PURGE VALVE OPERABILITY REPORT

SNUPPS PROJECT

DECEMBER 1983

This report has been prepared to allow the NRC to close out the confirmatory items (Number 28, TMI Action Plan II.E.4.2) for Callaway and Wolf Creek.

COMPARISON OF AVAILABLE ACTUATOR TORQUE
TO REQUIRED TORQUE AT VALVE

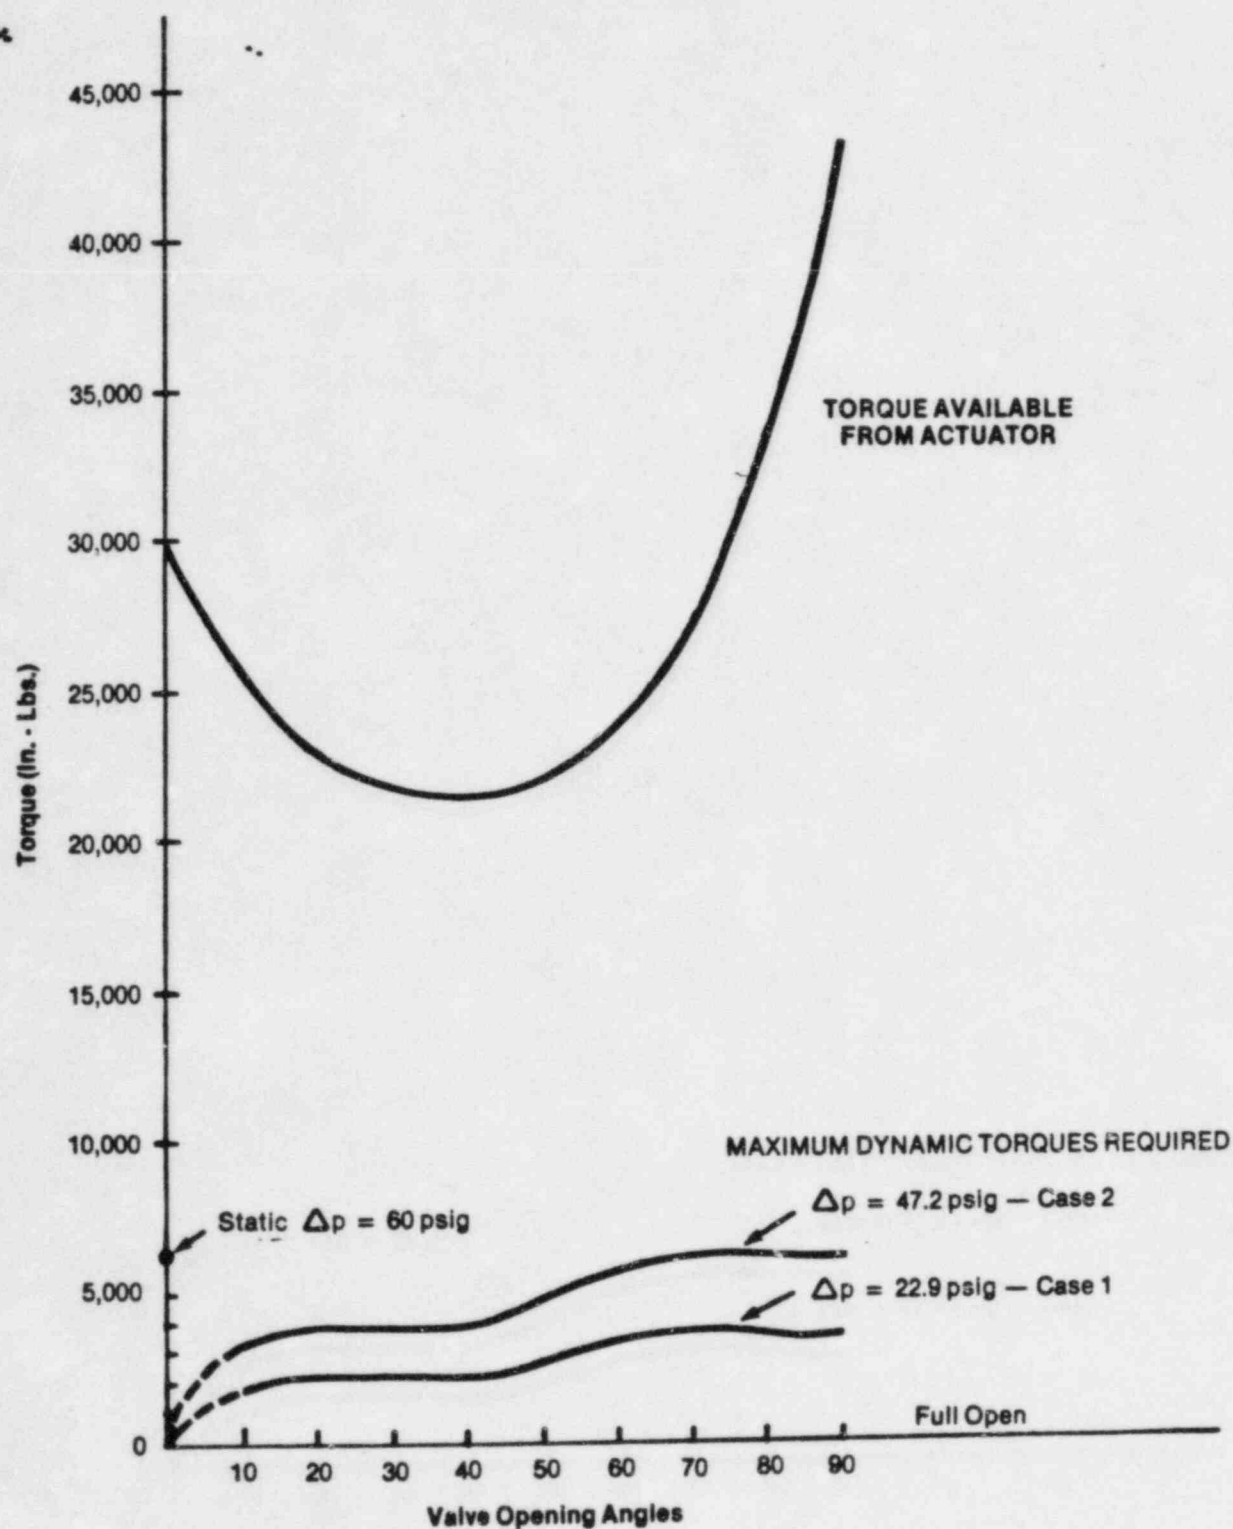
13. Does the maximum torque developed by the valve during closure exceed the maximum torque rating of the operators? Could this affect operability?

required double, as suggested by the NRC as a worst case*, significant margins would still remain between the available torque from the actuator and the required torque to close the valves outside of the containment. As shown in Figure 5 and Table 1, the excess torque available ratios for the design case range from 7.0 to 14.5 in the open positions. Should the dynamic torques required double, a margin ratio of 3.5 to 7.2 would still remain between the available torque and the required torque to close the isolation valves outside of the containment.

The available actuator torques and the required torque at the valve for each 10 degrees of opening are shown in Figure 5.

As shown in Figure 5, adequate spring-driven torque output is available from the actuator to close the valve from any open position (regardless of external ambient pressure). Since both the unpressurized side of the piston casing and the solenoid and Versa valves are vented to the same external ambient pressure, there is no effect on valve closure.

The required torque at the valve and the actuator-supplied torque are shown in Figure 5. No concerns exist that could affect valve operability.

Torque - Pressure Drop Relationships used in
Butterfly Valve Dynamic Torque Coefficient Selection

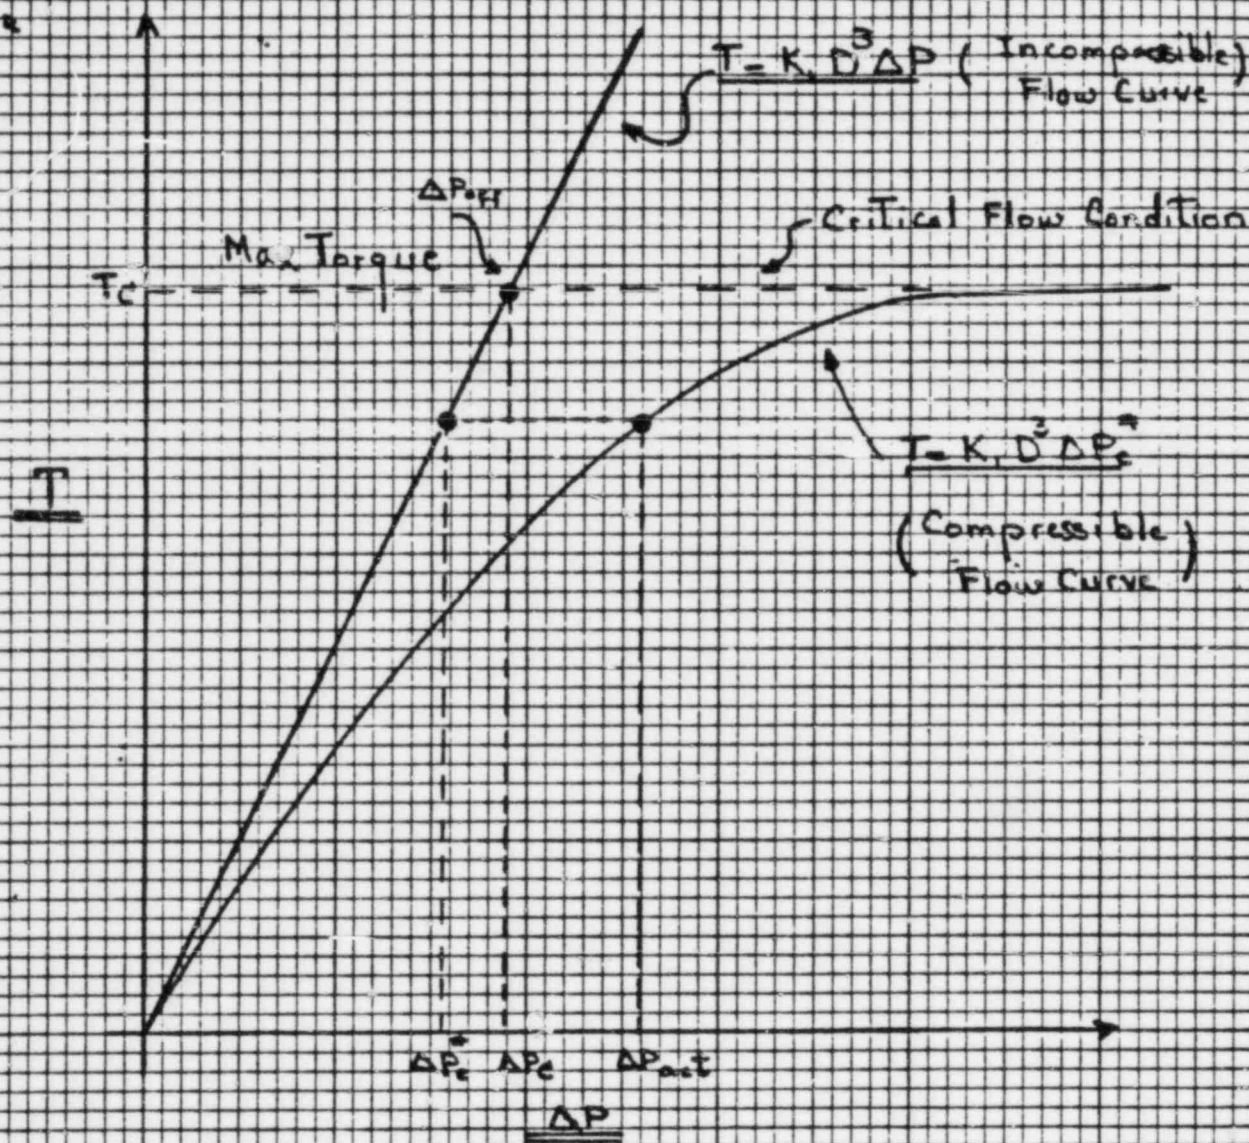
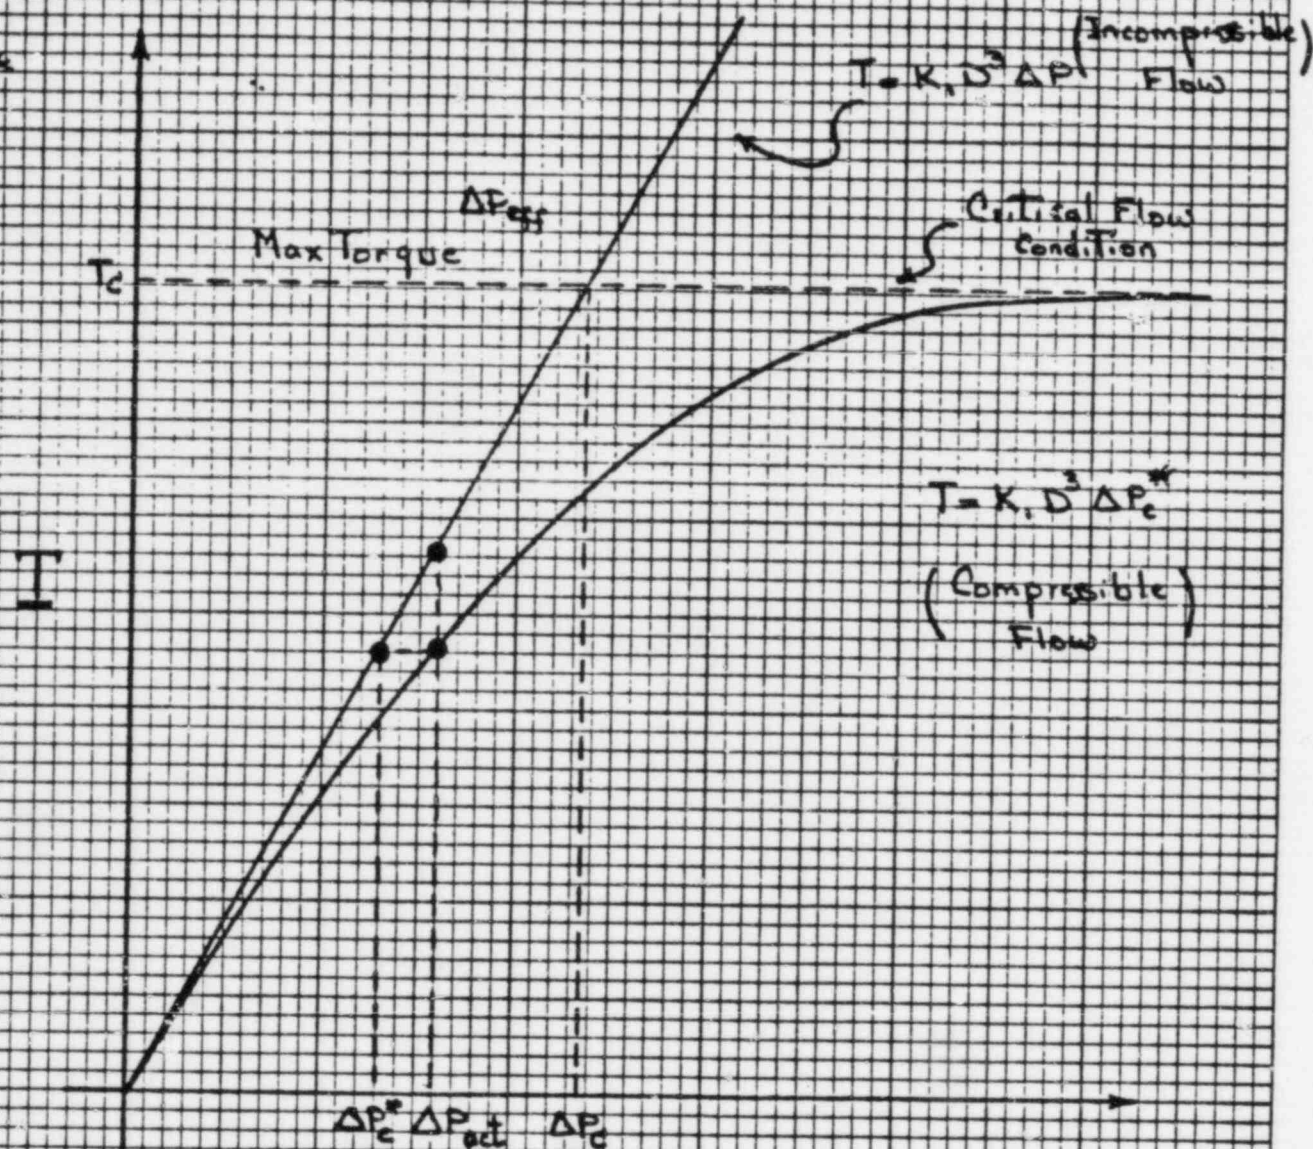
2. Were the dynamic torque coefficients used for the determination of torques developed, based on data resulting from actual flow tests conducted on the particular disc shape/design/size? What was the basis used to predict torques developed in valve sizes different (especially larger valves) than the sizes known to have undergone flow tests?

b. Application of the conclusions from the ISA paper is presented in Attachment 2, Selection Figures 1 and 2: "Torque-Pressure Drop Relationships Used in Dynamic Torque Coefficient Selection," which are representations of the Figure 5 curves from the ISA paper. These show how the torque values for compressible flow are conservatively determined and related to incompressible flow torques. It should be noted that the compressible flow curve reaches a critical flow condition at larger ΔP values, resulting in a maximum torque value (T_c) that cannot be exceeded, regardless of how large ΔP becomes.

1. A ΔP_{eff} value is obtained from the Fisher sizing tables based on the absolute inlet pressure value, type of disc, and flowing fluid.
2. If the actual ΔP is greater than ΔP_{eff} , then the ΔP_{eff} value is used, corresponding to T_c (the maximum possible torque). This is conservative, predicting a higher torque than is actually present (see Figure 1 in Attachment 2).
3. If the actual ΔP is less than ΔP_{eff} , then ΔP_{act} is used, which predicts a more conservative (greater) torque, but less than T_c (see Figure 2 in Attachment 2).
